VSP-37  
July 7, 1982

VENDOR SERVICE PUBLICATION

Subject: Bendix Service Bulletins 615, 620, 621

Figure 1. 10-157197 Distributor Gears with Different Timing Marks

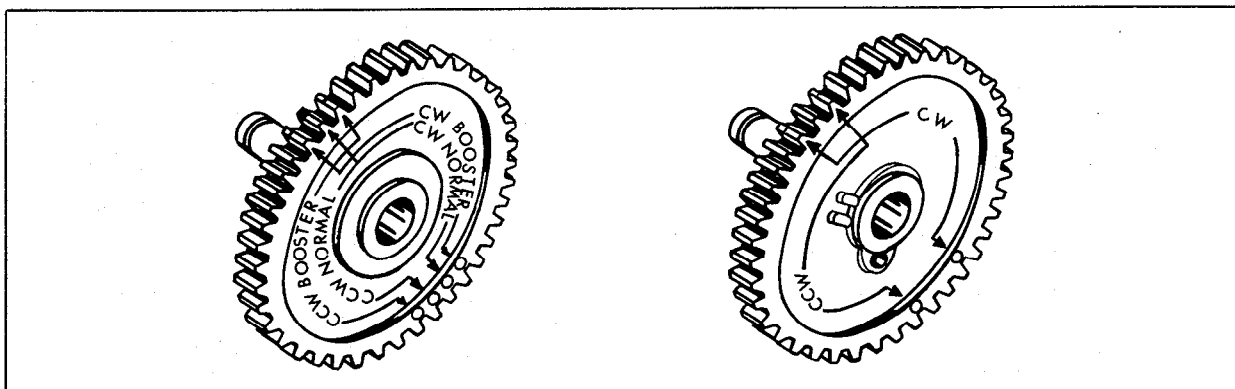
2. If old distributor gear, P/N 10-157197, which incorporated two different molded timing identification marks was used (see figure 1), proceed as follows:

- Remove paint from booster timing positions with suitable solvent.
- Locate normal timing tooth between CW and CCW booster chamfered teeth and paint this tooth and the applicable inner timing mark with red Dykem or red lacquer in accordance with figure 2 or figure 4 for appropriate gear.

Figure 3. Timing Marks on Present Production Distributor Gear Kit Assembly 10-357586

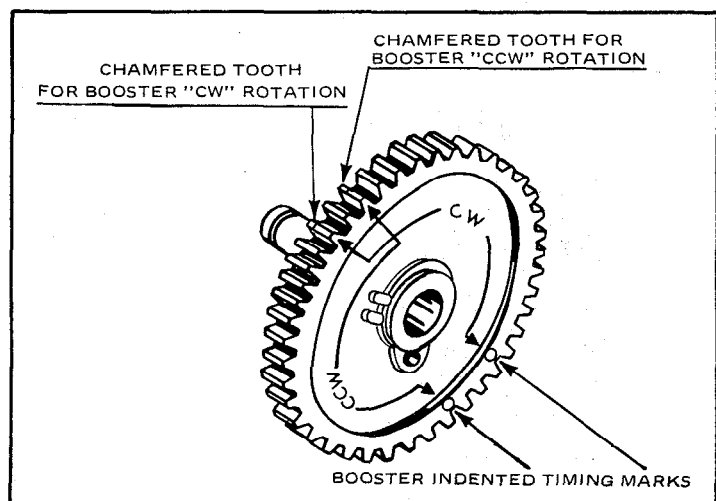
3. If present production distributor gear as supplied in kit P/N 10-357586 is used (see figure 3) proceed as follows:

- Remove paint from booster timing positions with suitable solvent.
- Locate normal timing tooth between CW and CCW booster chamfered teeth and paint this tooth and the applicable inner timing mark with red Dykem or red lacquer in accordance with figure 4.

Figure 4. Present Production Distributor Gear Assembly with Additional Timing Marks Painted

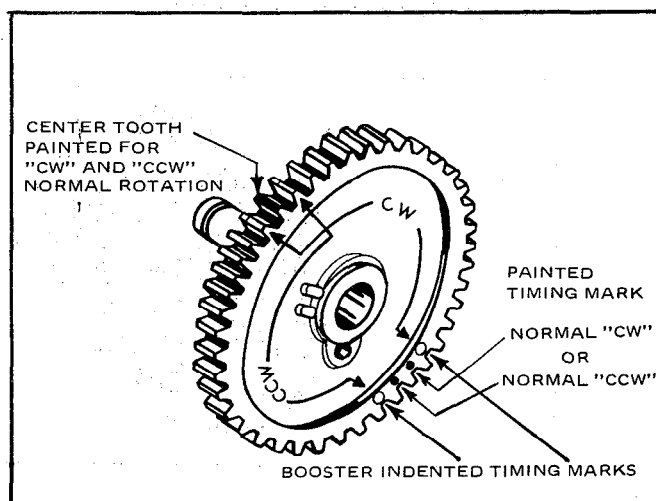
The molded timing marks incorporated in new present production nylon spare part gears, as supplied in kit, P/N 10-357586, are for the booster timing position. Before installation of a new gear kit, the applicable normal timing mark and center tooth must be marked with red

Dykem or red lacquer as illustrated in figure 4.

- Reassemble the magneto using the applicable **normal** timing mark on distributor gear.
- After magneto has been reassembled, identify the magneto by stamping the letter "R" in the upper left hand corner of the identification plate using a 1/16 inch metal stamp.
- Make an appropriate engine Log Book entry indicating that this Service Bulletin has been complied with, recording magneto serial number.

**Insulated Gear Configuration**  
(Incorporating 10-357586 Kit parts with *incorrect* washer.)  
**Figure 2**

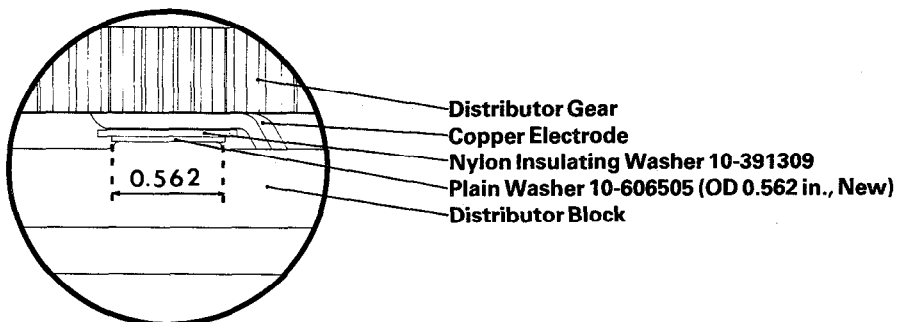
It has been determined that plain steel washer P/N 10-349511 installed on the gear axle between the nylon insulating washer P/N 10-391309 and the distributor block bronze oil-lite bushing (see figure 2) can cause electrical flash-over in the distributor at altitude. Inspect for compliance as follows:

1. Remove the top timing plug.
2. Using a concentrated light beam (a pen light or equivalent) look into the timing hole at the area between the distributor gear and the distributor block parts for existing washer configuration.
3. Current configuration should be as shown in figure 3.
4. Rework magneto whenever configuration is as shown in figure 2.
5. An acceptable configuration is shown in figure 1.

1. Remove magneto from engine.
2. Disassemble as required using procedures described in Bendix Overhaul Manual Form No. L-205-10 for S-20 and L-527-4 for S-200 series magnetos.
3. Remove retaining ring and plain washer. Discard retaining ring. Remove distributor gear from the distributor block.
4. Inspect the distributor block for burning or carbon tracking and serviceability. Replace if defective.
5. Remove old plain steel washer P/N 10-349511 (OD 0.750 in.) and nylon insulating washer P/N 10-391309 from the gear axle.
6. Reinstall nylon insulating washer P/N 10-391309 and install new plain washer P/N 10-606505 (OD 0.562 in.) on gear axle. See figure 4 for assembly order.
7. Wipe distributor gear axle clean, then reinstall it in the block. Place plain washer P/N 10-349511
